Comment Date: April 21, 2011 15:15:42PM
Solar Energy Development PEIS
Comment ID: SolarD11747

**Standard Review Form
Preliminary Draft Solar Energy Development PEIS**

Section or Chapter Number and Date of Reviewed Document: Reviewed 20 April 11, Executive Summary

Figure 3

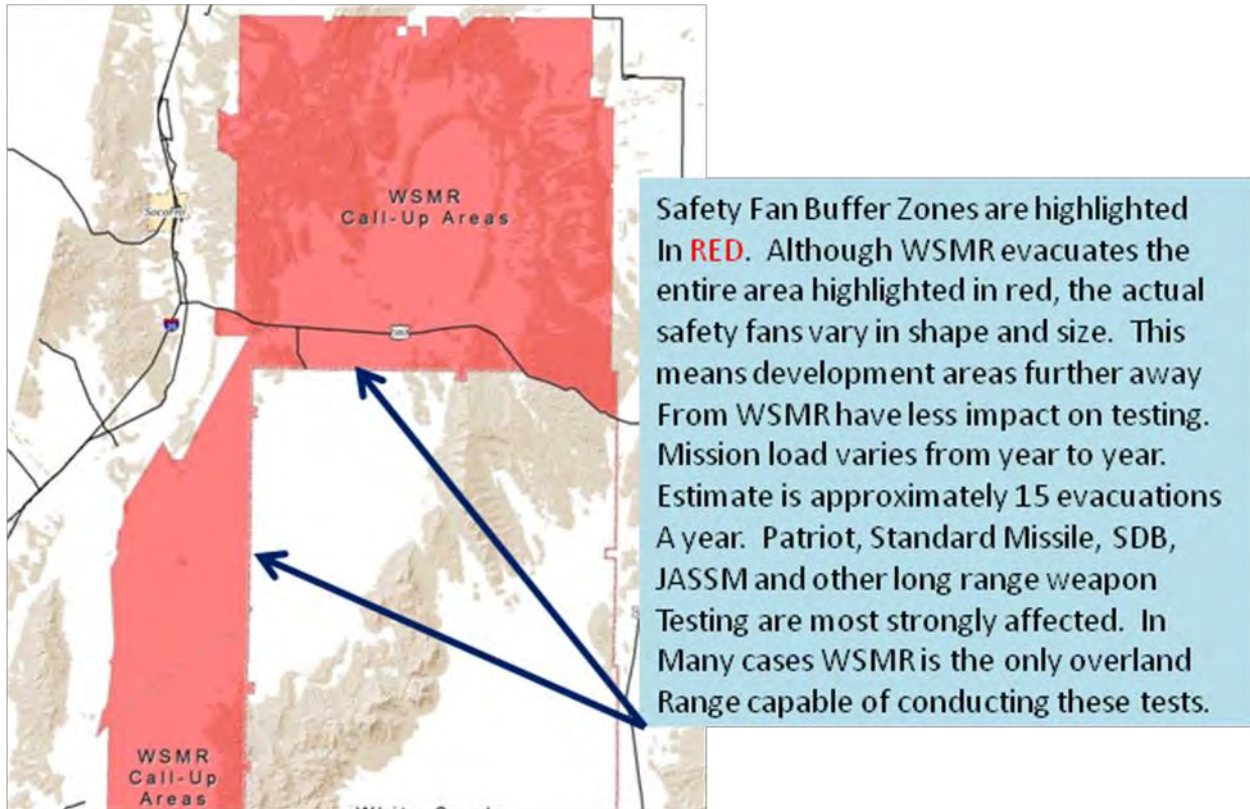
- iii. Safety Fan Debris. The Near West Group encompasses numerous safety fans (figure 3). The close proximity results in a significant number of safety fans overlays and a resultant increase in risk to infrastructure or relocation of mission profiles. The relocation alternative has the effect of reducing the size of WSMR. Systems particularly affected include Small Diameter Bomb, Standard Missile, Patriot, and others. The impact of these routes precludes execution of these missions at WSMR.

Figure 4

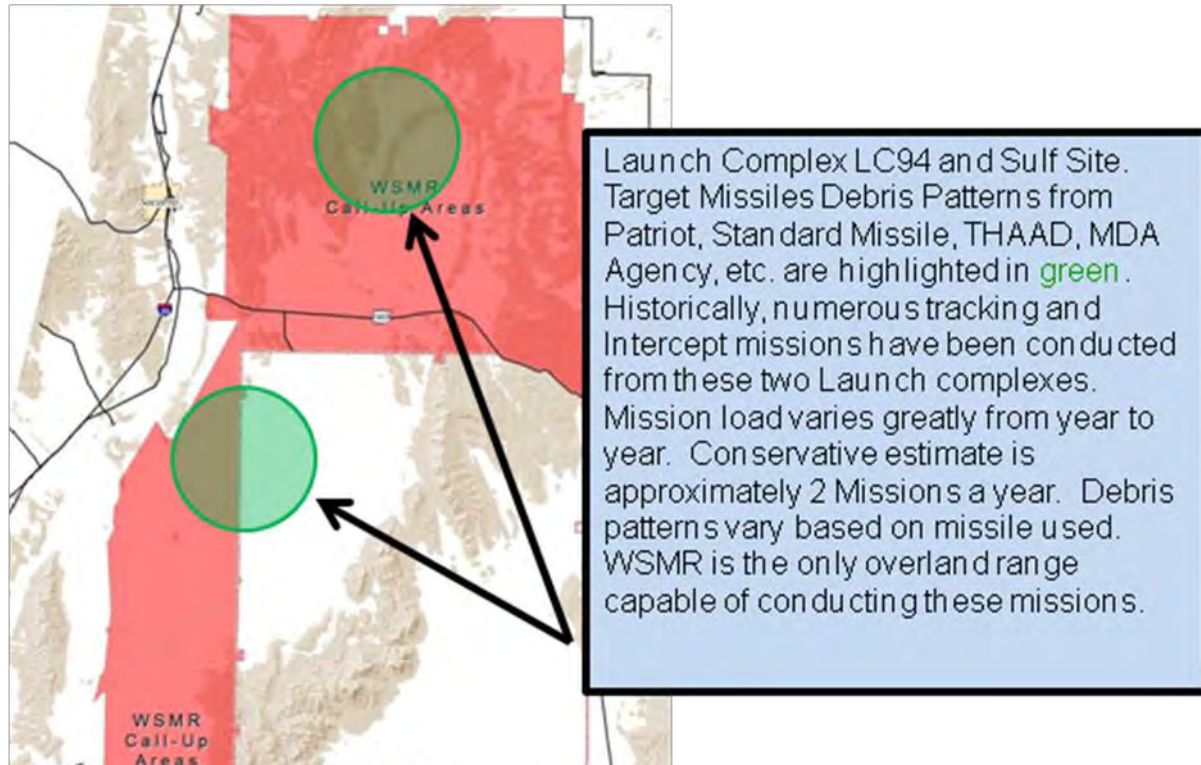
- ii. **Target Debris.** Target Debris from LC94 may damage any development near this area (figure 4). Programs include Patriot, THAAD, MDA agency. Mission load varies significantly from year to year. Conservative estimate is approximately 1 mission per year. Debris patterns vary based on target used. The estimated impact to WSMR operations is considered significant.

Figure 5

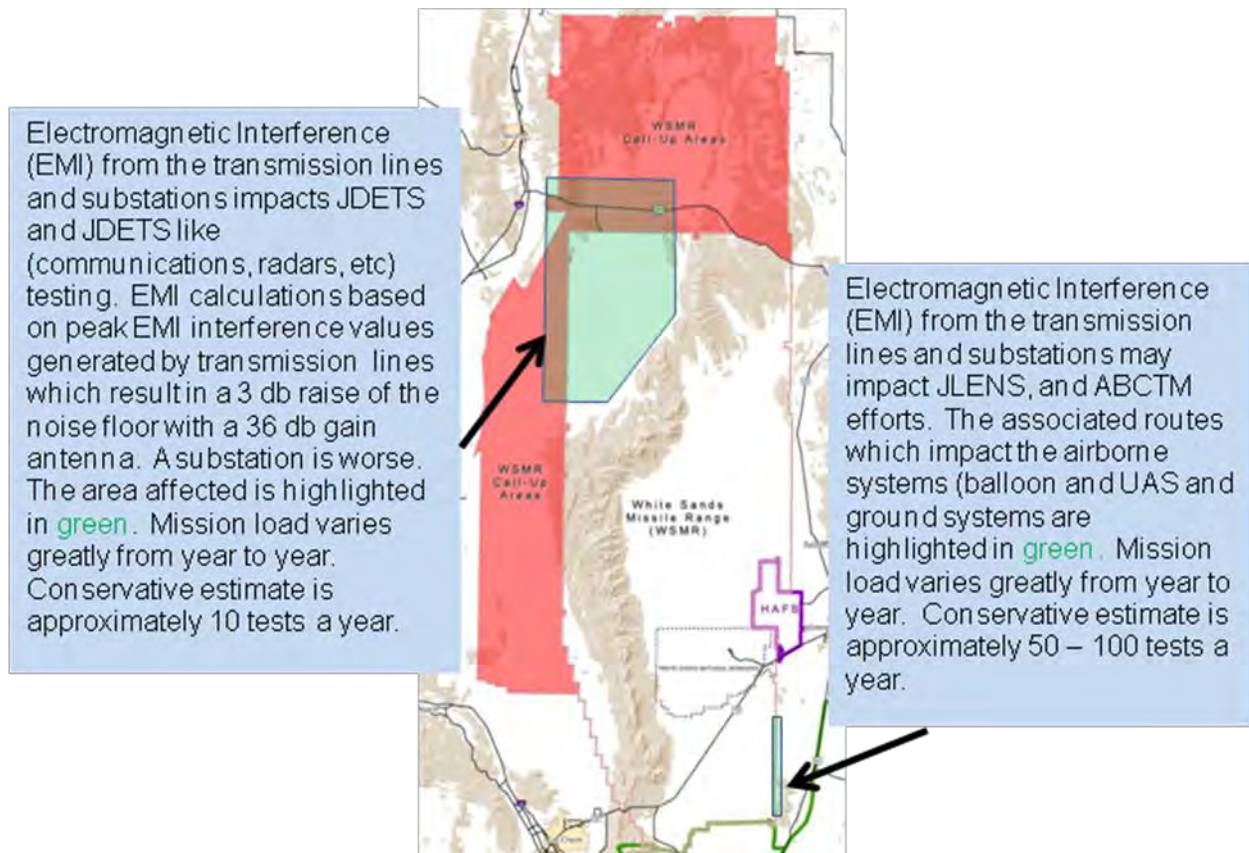
- ii. EMI. Airborne C-IED systems will be negatively affected by substations and high voltage powerlines in the Near West Group. The impact will be a reduction in the area these systems can be tested and has the effect of reducing the WSMR airspace (see figure 5). Some potential areas are close to Joint Directed Energy Test Site

(JDETS) testing and will adversely impact C-IED testing. The impact to WSMR operations is considered significant.

Figure 1. Delamar Valley Solar Energy Zone recommended boundary adjustments.

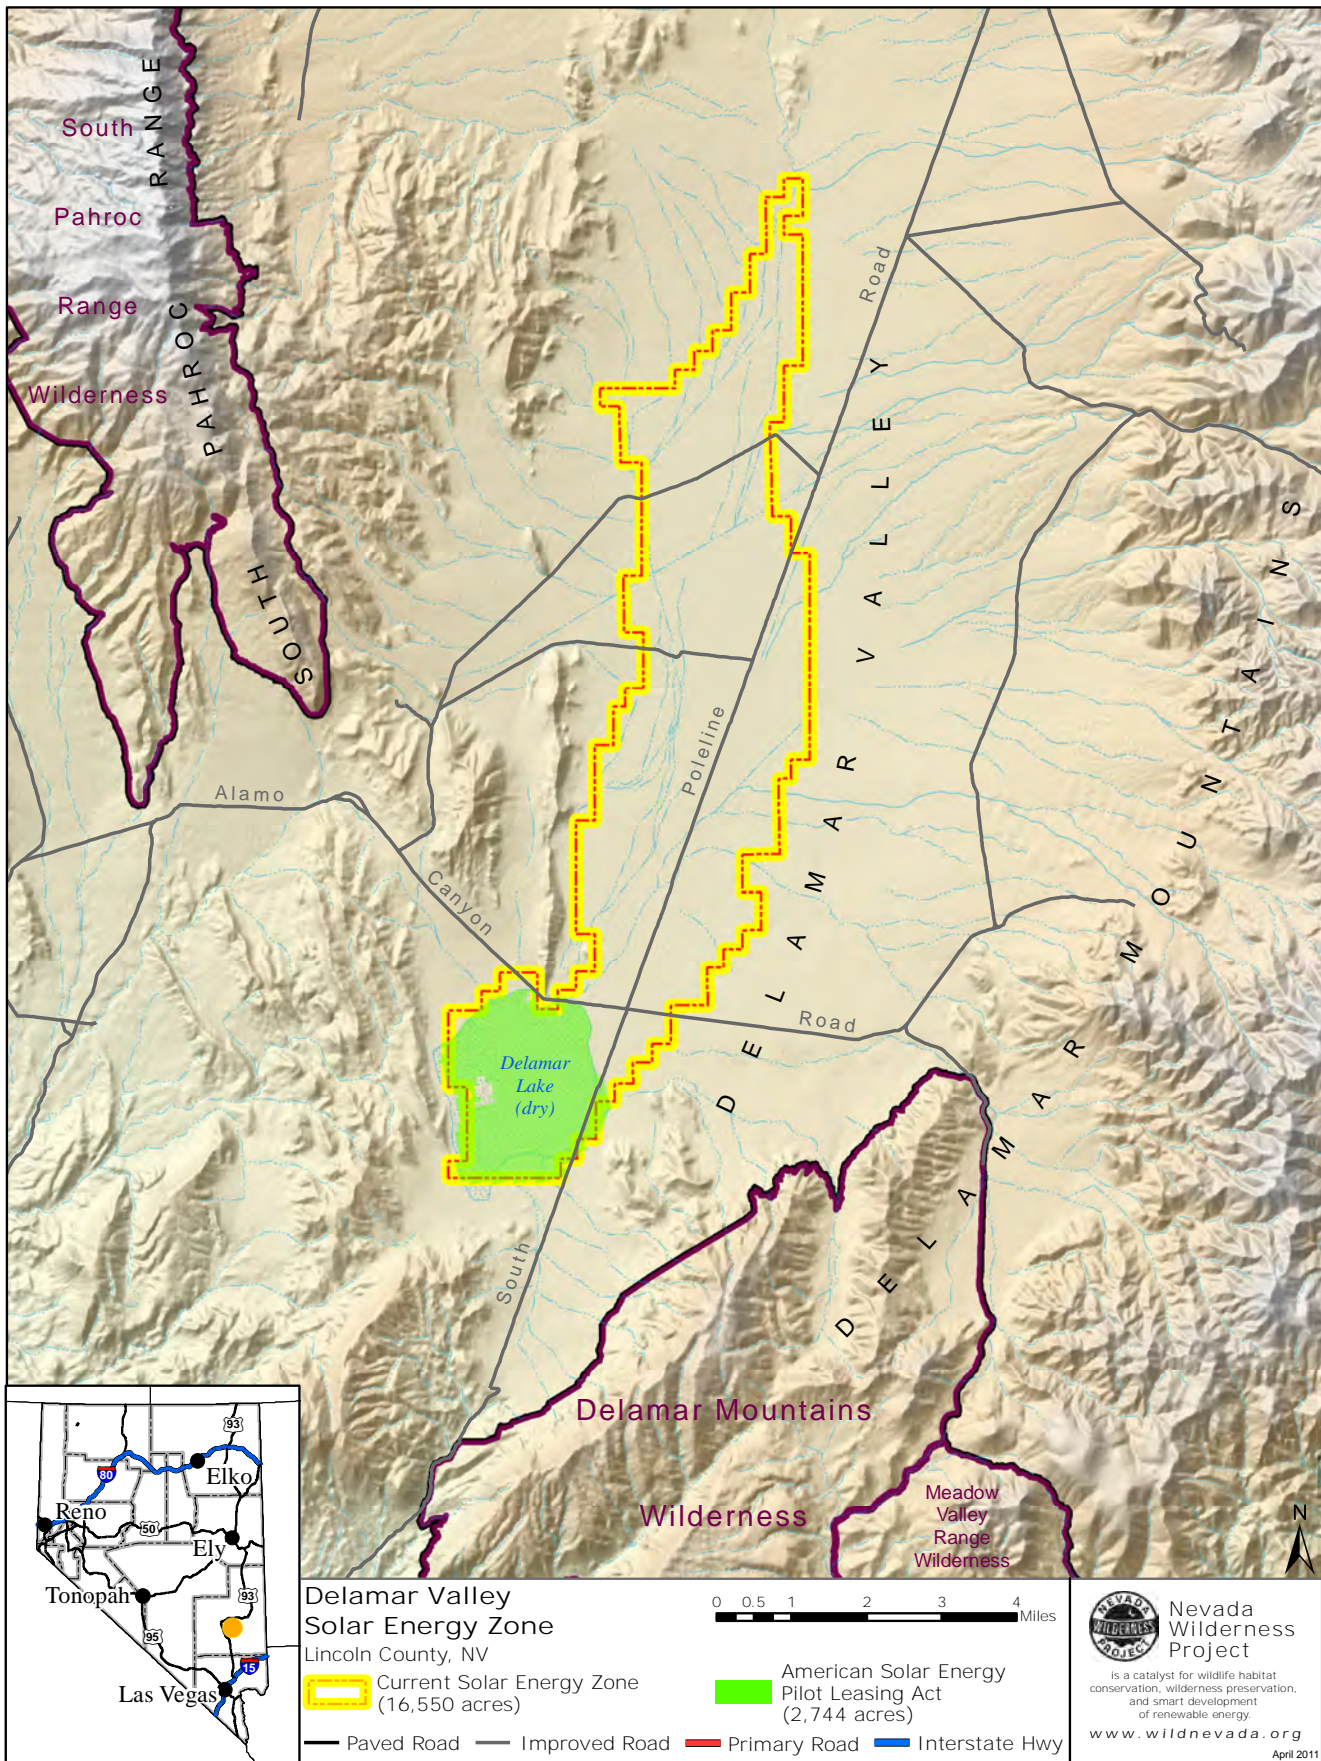
As currently drawn, the SEZ includes some areas that are not appropriate for designation as a SEZ. We would like the BLM to revise the boundary of the SEZ as shown in the included map as the green area labeled “American Solar Energy Pilot Act” (Fig. 1).

Figure 3. Dry Lake Solar Energy Zone recommended boundary adjustments.

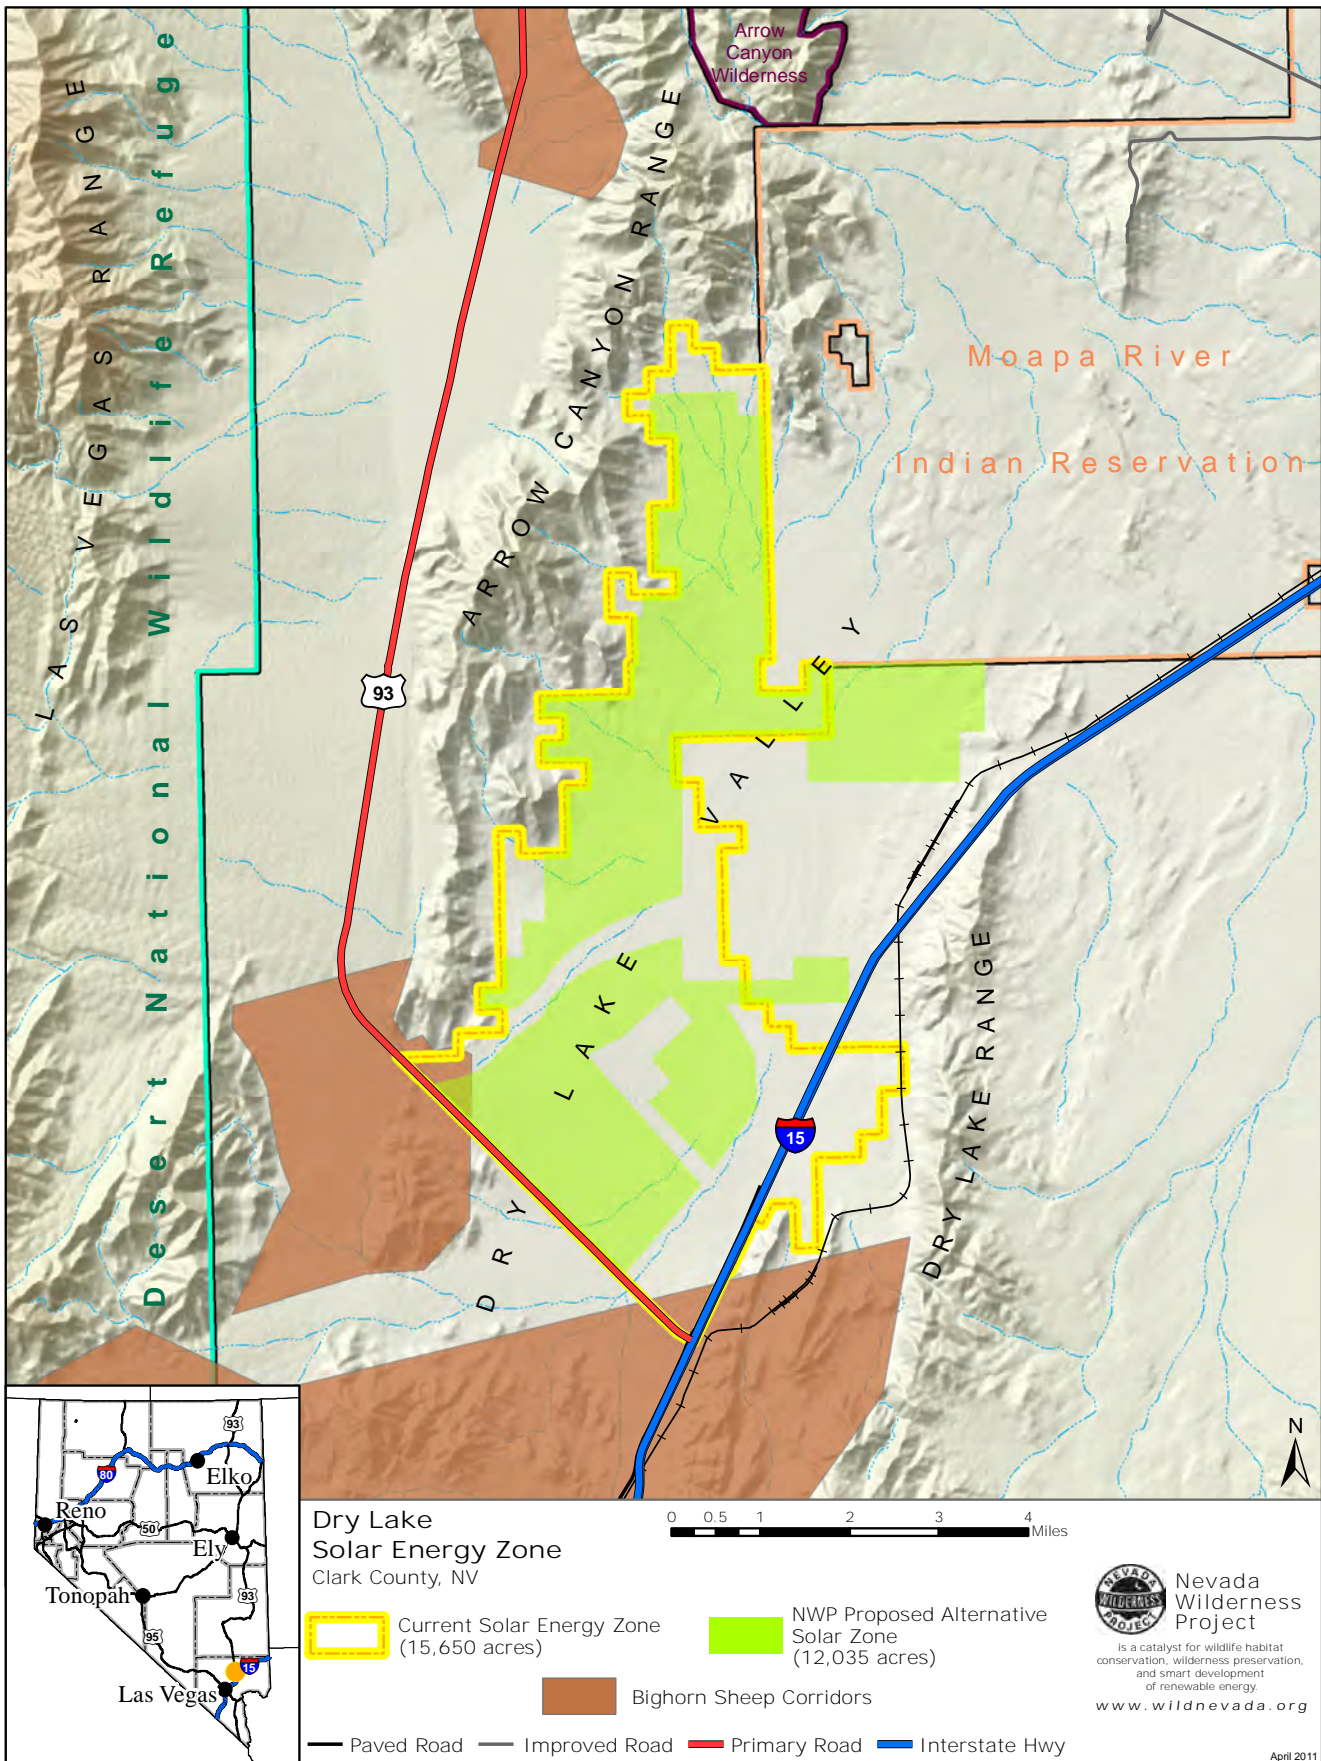
As currently drawn, the SEZ includes some areas that are not appropriate for designation as a SEZ, including state mapped bighorn sheep wildlife movement corridors. We ask the BLM to revise the boundary of the SEZ as indicated in the included map for the Dry Lake area (Fig. 3).
